Product Bulletin for Medium Bi-Pin & High Output Recessed Double Contact Fluorescent Lampholders

Detter Than Ever... Our Redesigned Pedestal-Type Fluorescent Lampholders

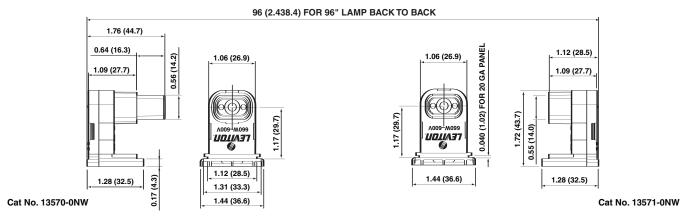
Leviton's newly redesigned Pedestal-Type fluorescent lampholders simplify fixture design and increase options for OEMs. The Medium Bi-Pin and High Output 800MA and 1500MA Recessed Double Contact lampholders are molded out of high temperature, arc-resistant thermoplastic with a 94V-0 flammability rating. Adding a new dimension, the previously round plunger area has been reshaped into a rectangle, resulting in smoother travel during lamp insertion. Now available shunted for use with instant-start ballasts, the lampholders fit the same 20-ga. panel openings as previous Leviton models.

- High temperature, arc-resistant thermoplastic with a 94V-0 flammability rating
- Rectangular plunger area provides smoother travel during lamp insertion
- Available shunted for use with instant-start applications
- Quickwire terminals accept No. 18 or No. 16 AWG solid wire, stripped 3/8" to 1/2"
- Silver-plated contacts
- Fits 20-ga. panel openings, same as previous Leviton models
- Meets proposed UL requirements for instant-start applications
